**Subject:** Attention DA Team Re DA2025/1570 Please confirm receipt of submission

Re: DA2025/1570

## Lot 11 DP 12838, 290 Lower Plateau Road, Bilgola Plateau

The below image taken 16/08/2024 depicts the abundant fauna on my block, and neighbouring Tree 18 adjacent to the sandstone outcrop.

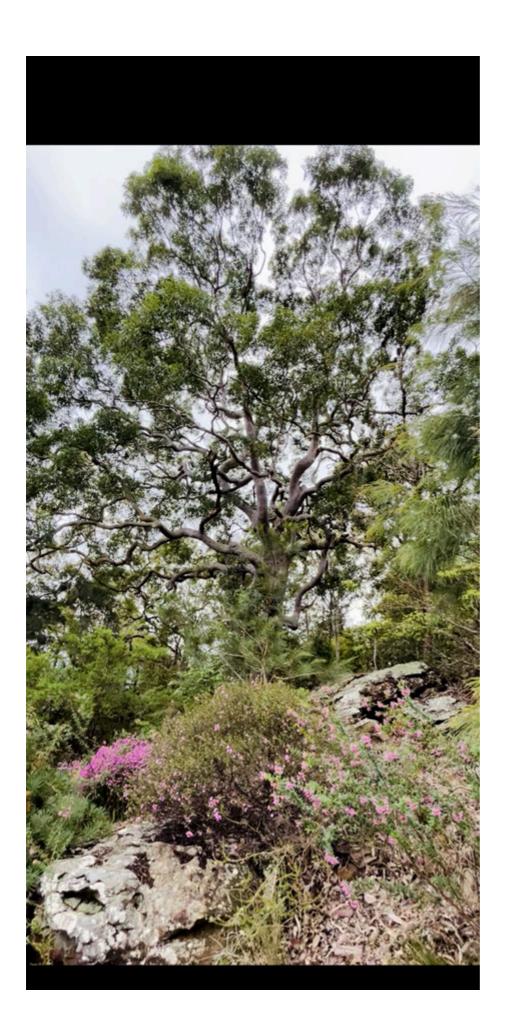
For example, Tree 18, a magnificent Angophora costata has a cumulative encroachment impact (26%) [5] beyond acceptable standards, being classified as "Major >20% of NRZ or any encroachment into SRZ/ SRZ breach = automatically Major Detailed investigation; design alternatives must be explored; viability must be demonstrated."[6]

This aspect of the "Tree Sensitive Design and Construction solution" to take adequate measures to protect the environment *have not been sufficiently prioritised* and therefore do not meet the Australian Standard. There are several other unacceptable encroachments to Cat A Trees (T28 is 36%!) which will inevitably lead to the death of the tree.

I have approached Council prior to the lodgement of this DA for assistance with T18's protection (15/08/25), as the neighbouring block had been sold and the potential for its development seemed imminent. It, along with the exceptional rock outcrop must be protected at all costs.

Additionally, will Council please consider the implications to the third party (owner of 288 Lower Plateau Road) should Council approve this Application, and the tree is damaged or dies? Who bears this responsibility and accountability for compensation?
